Issue No. F1-122-T-001-1

TDK Corporation

Notice of Process Change

Name of change	Change of carrier tape material		
Customer Part #	See attachment-1	TDK Part #	See attachment-1
Before	After	Remark	
Flat type Material = pulp Color = white	→ Emboss type Material = plastic Color = black	Please refer to the attachment-2 and the attachment-3

**Carrie Tape Dimension for Size : 1.0 x 0.5 mm**

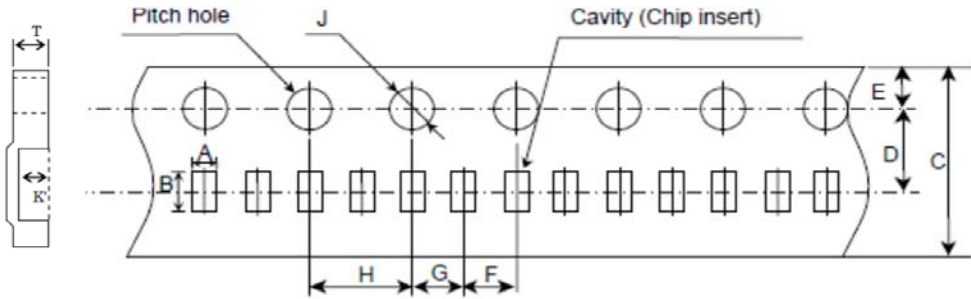
**Current**

**Flat type**

Symbol	A	B	C	D	E	F
Dimension	0.62 ± 0.03	1.12 ± 0.03	8.0 ± 0.2	3.5 ± 0.05	1.75 ± 0.05	2.0 ± 0.05
Symbol	G	H	J	K	T	
Dimension	2.0 ± 0.05	4.0 ± 0.05	Ø1.5	+0.1 0 ①0.55±0.03 ②0.45±0.03 ③0.37±0.03	0.61 ± 0.02

**After**

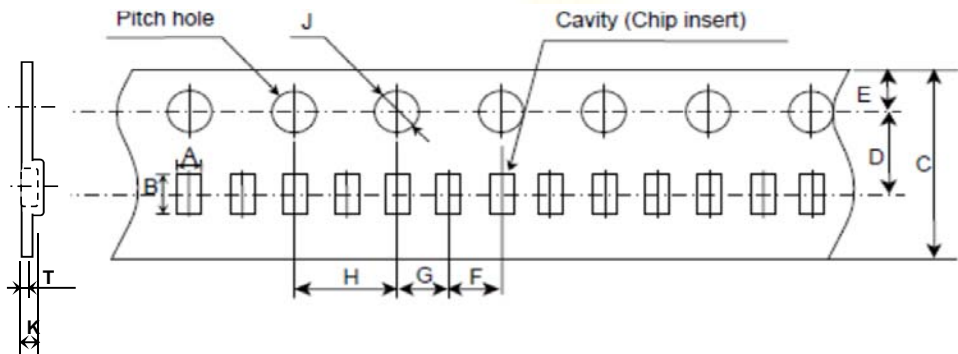
**Emboss type**

Symbol	A	B	C	D	E	F
Dimension	0.62 ± 0.05	1.12 ± 0.05	8.0 ± 0.2	3.5 ± 0.05	1.75 ± 0.1	2.0 ± 0.05
Symbol	G	H	J	K	T	
Dimension	2.0 ± 0.05	4.0 ± 0.05	Ø1.5	+0.1 0 ※0.58Max	0.20 ± 0.05

※Specified by product thickness

**Carrier Tape Dimension for Size : 1.6 x 0.8 mm**

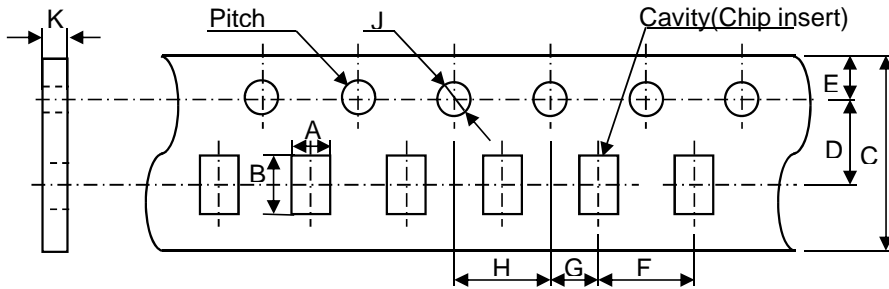
**Current**

**Flat type**

Symbol	A	B	C	D	E	F	
Dimension	0.97 ± 0.05	1.80 ± 0.05	8.0 ± 0.2	3.5 ± 0.05	1.75 ± 0.1	4.0 ± 0.1	
Symbol	G	H	J	K			
Dimension	2.0 ± 0.05	4.0 ± 0.1	∅1.5	+0.1	①0.95±0.04 ②0.75±0.04 ③0.60±0.04 ④0.50±0.04		
				0

**After**

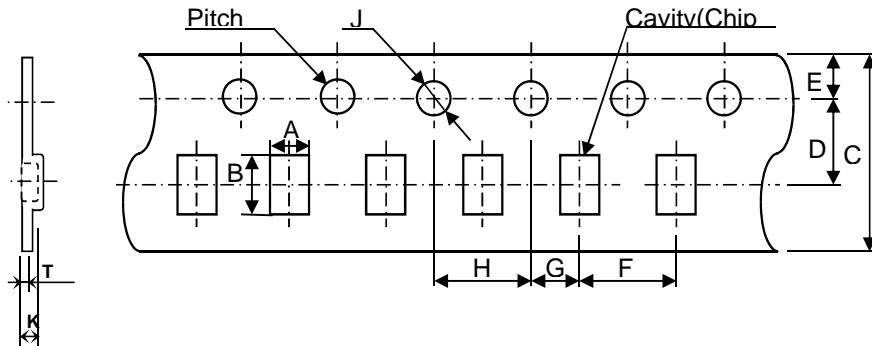
**Emboss type**

Symbol	A	B	C	D	E	F
Dimension	0.97 ± 0.05	1.80 ± 0.05	8.0 ± 0.2	3.5 ± 0.05	1.75 ± 0.1	4.0 ± 0.1
Symbol	G	H	J	K	T	
Dimension	2.0 ± 0.05	4.0 ± 0.1	∅1.5	+0.1	※1.0Max	0.25 ± 0.05
				0

※Specified by product thickness
